SUBJECT: MAIN LANDING GEAR SPRING ATTACHMENT LINK, P/N 560013-000; REMOVE AND REPLACE

AFFECTED: MOONEY M20J - S/N 24-3079 THRU 24-3122

PARTS LIST: KIT P/N - SBM20-244-1

FIGURE - M20-244-1

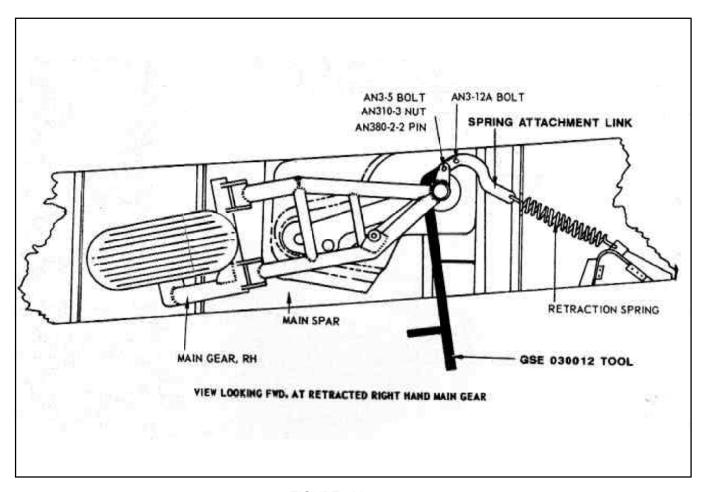
INTRODUCTION: THESE PARTS MAY HAVE BEEN INSTALLED WITHOUT PROPER HEAT TREATMENT.

- 5. Remove AN380-2-2 cotter pin and AN310-3 nut from spring attachment link bolt on main landing gear leg assembly. (See Figure 1)
- 6. Attach GSE 030012 special tool forward of spring attachment link, P/N 560013-000, with an AN3-12A bolt as shown in Figure 1. Rotate GSE tool in outboard direction using upper trunion shaft of landing gear leg as a fulcrum point.

- 7. AN3-5 bolt can be removed from link and MLG leg assembly when sufficient leverage is applied to GSE 030012 tool.
- 8. Remove AN3-12A bolt from GSE tool and old link. Remove 560013-000 link from retraction spring coil.

- 9. Place AN3-12A bolt back in GSE tool and a new link from this kit.
- 10. Remove and replace existing links, LH & RH gear, with the new links (included in kit) using reverse sequence of steps 4 thru 9.
